GRANDVIEW RESERVE
 DR HORTON
 FALCON, COLORADO

CONSTRUCTION DOCUMENTS
 GENERAL NOTES

SHEET
 GN1
 02

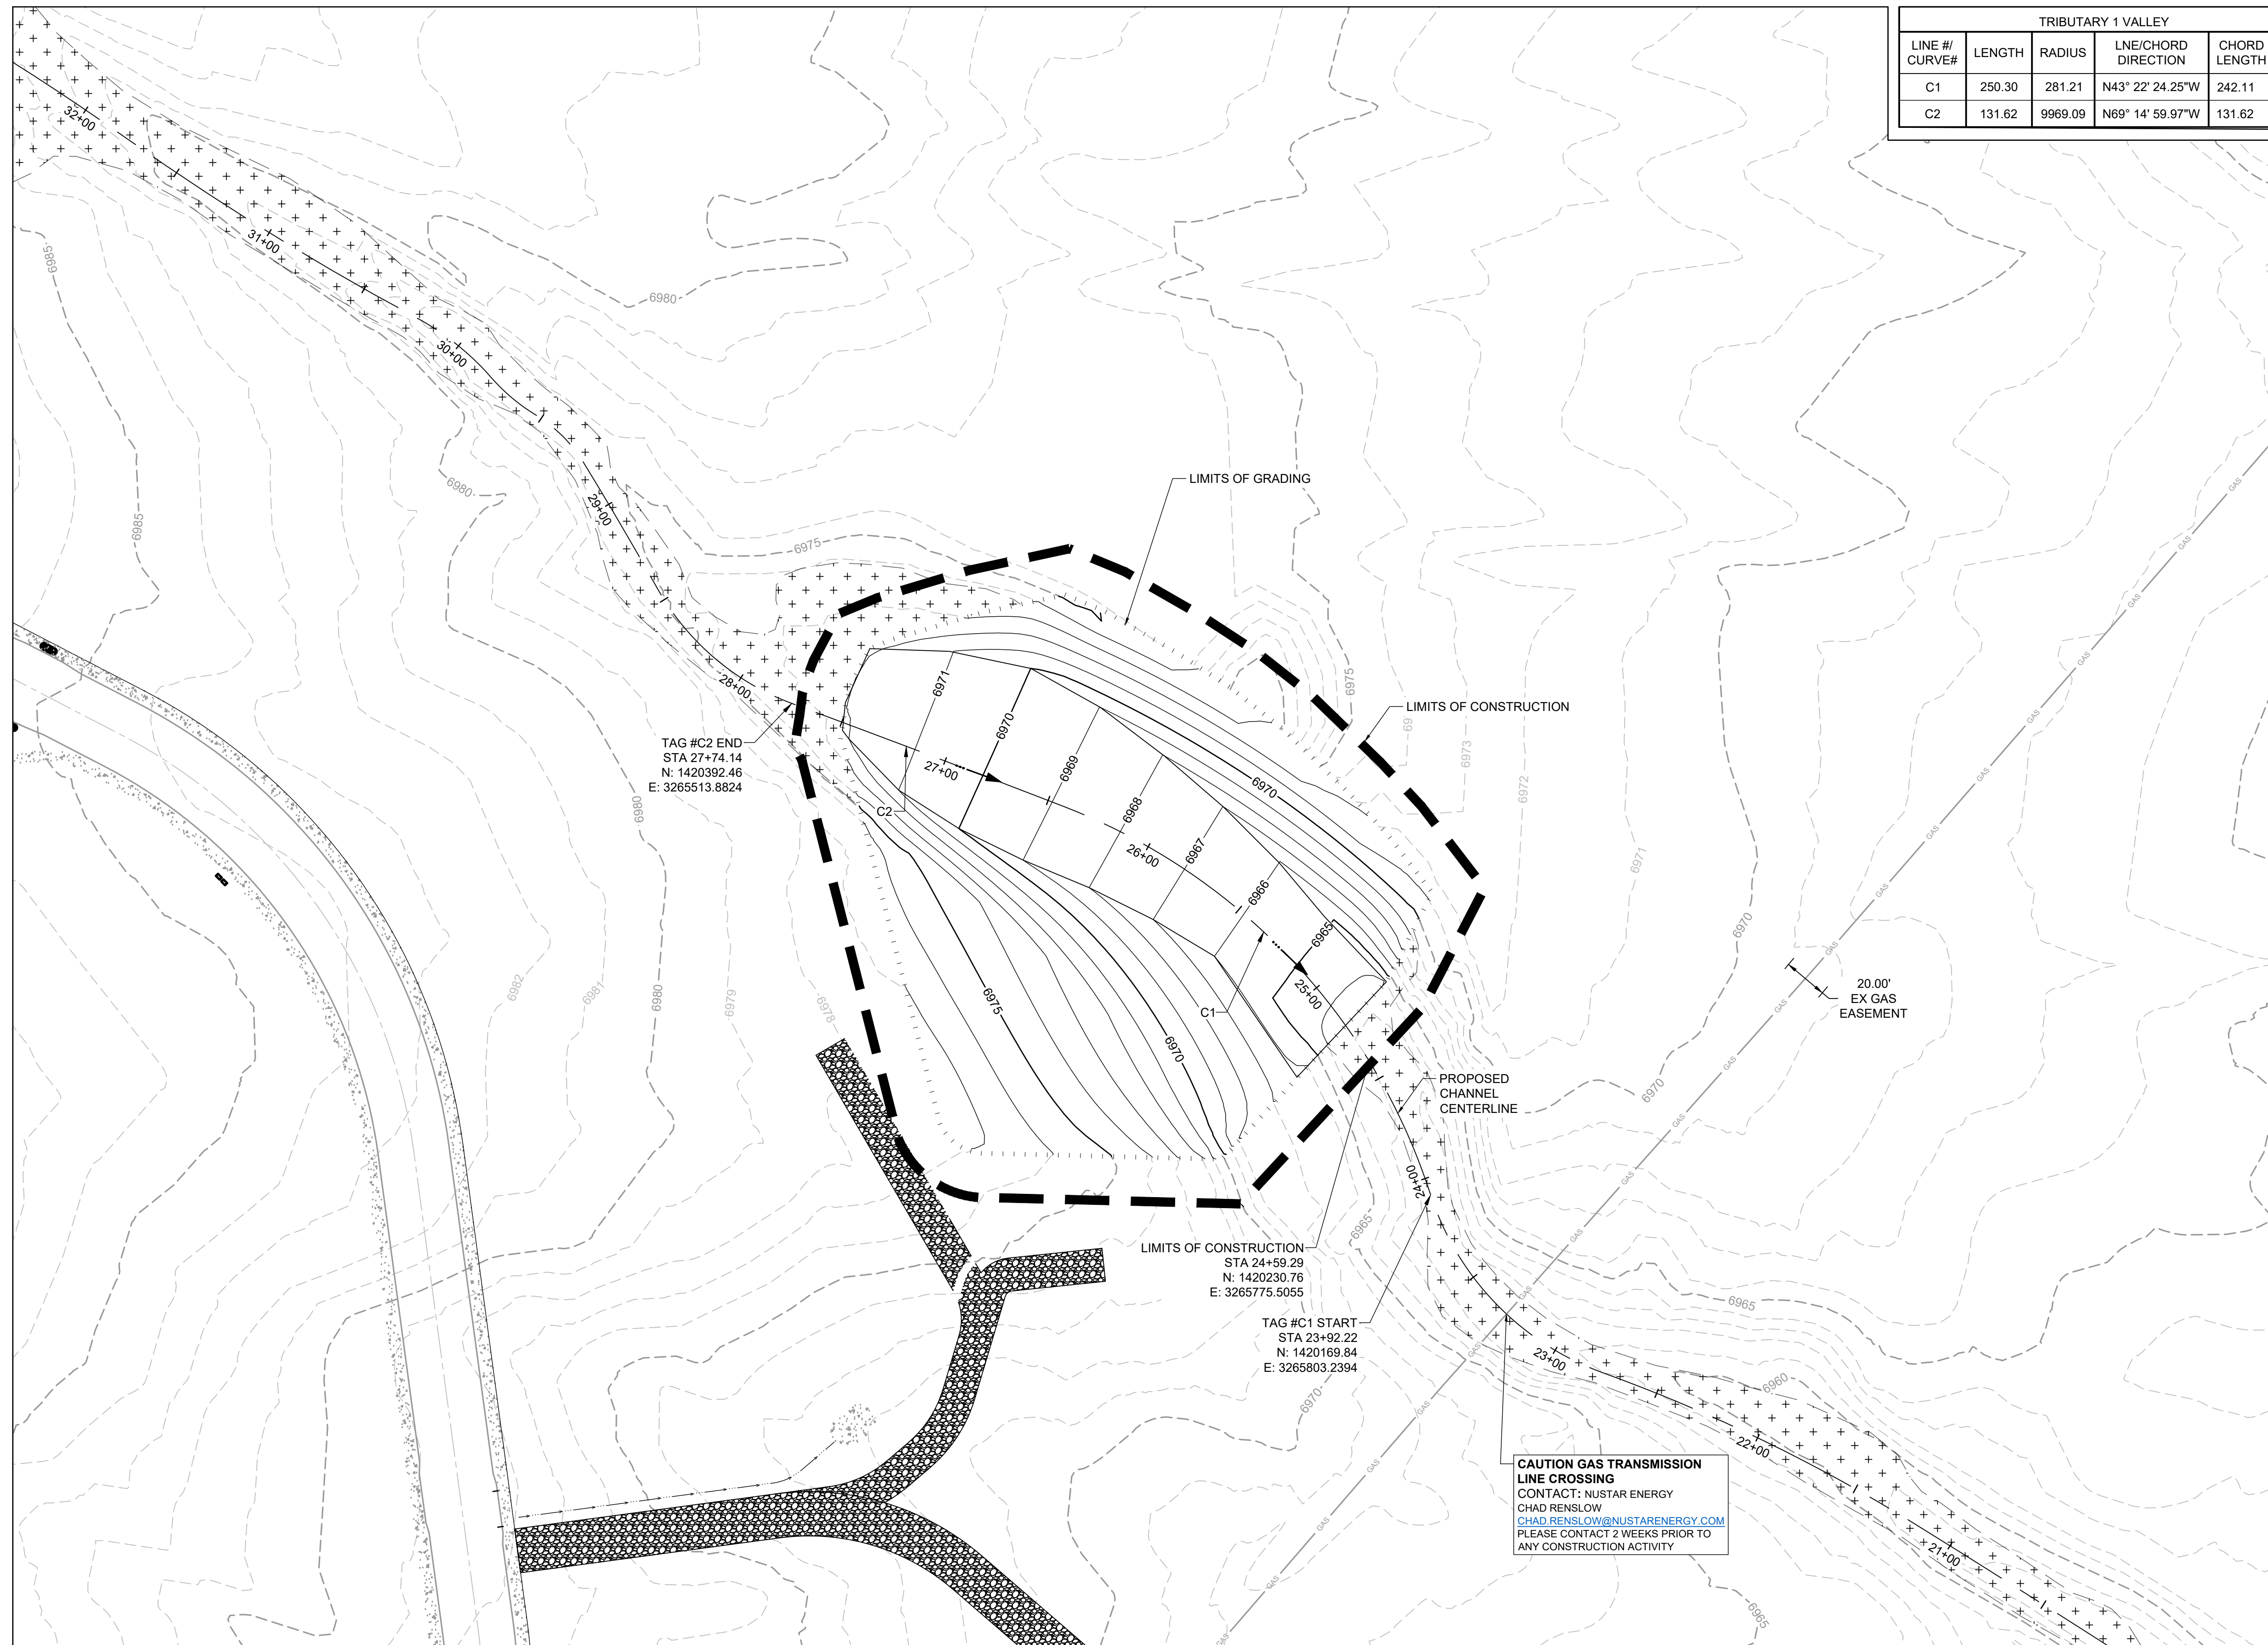
These values (in the approved deviation request) need to be met.

revise as needed

SHEET
PP6
 35

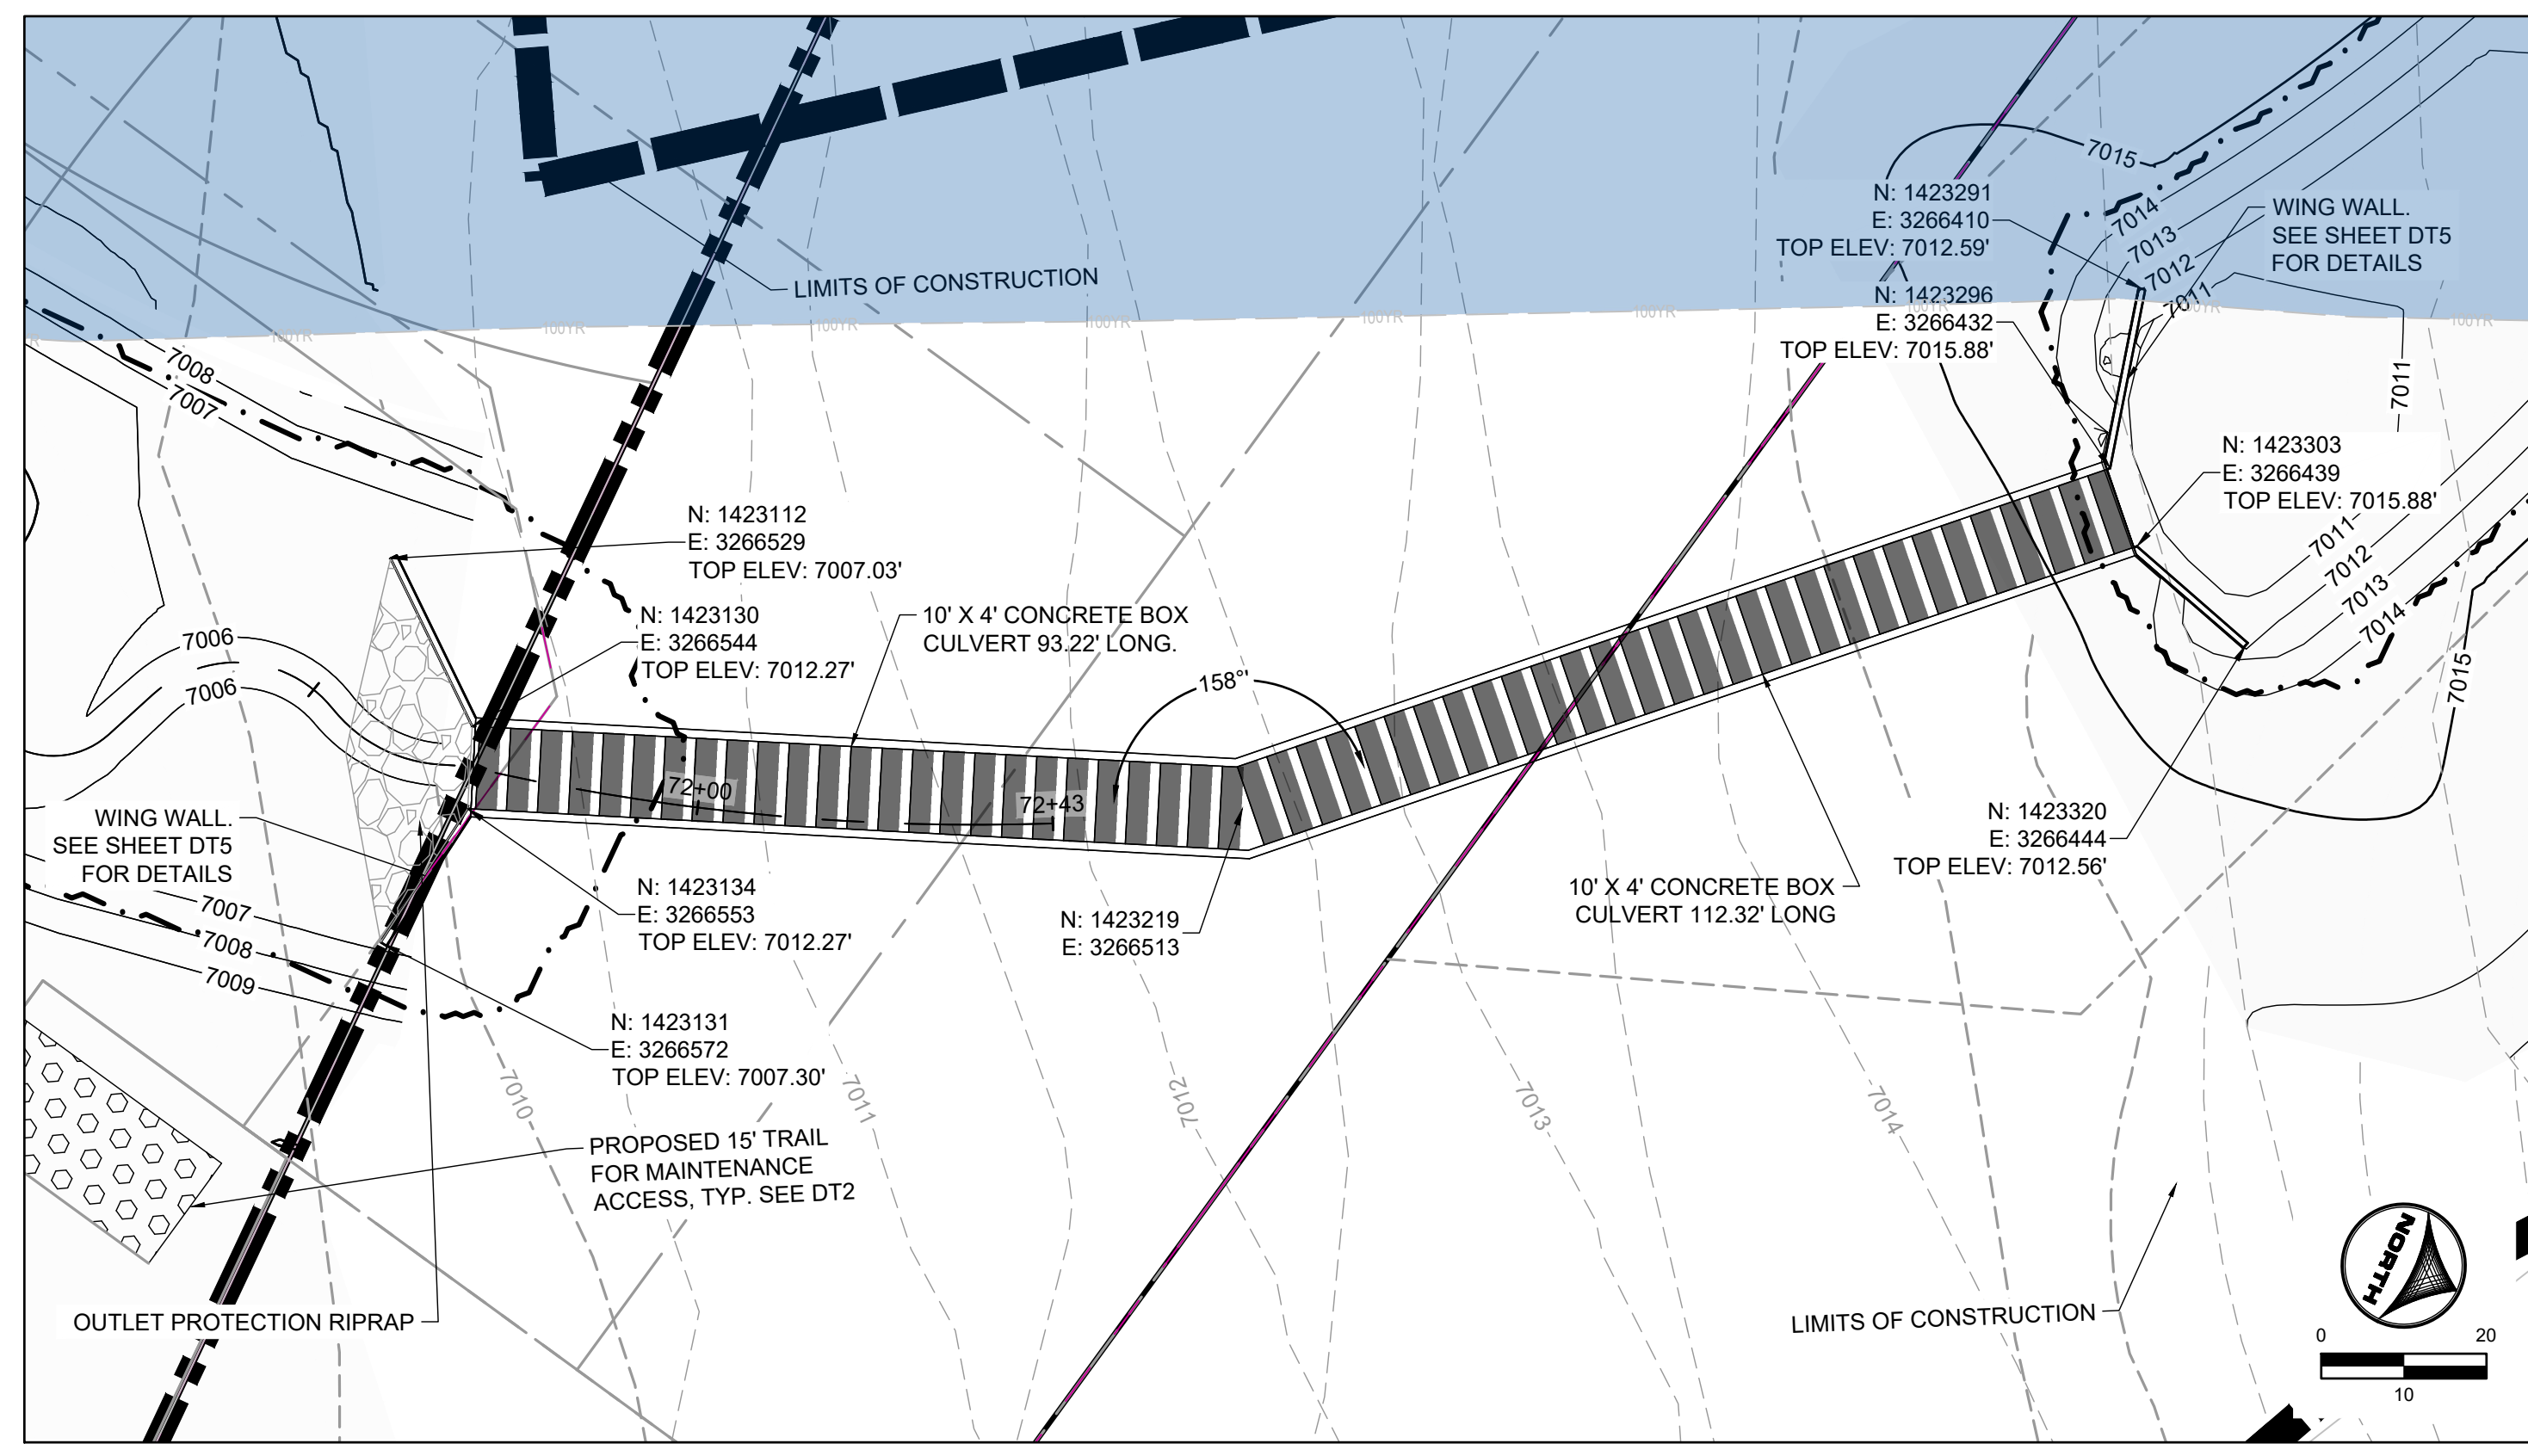
Verify that this is represented in HEC-RAS model
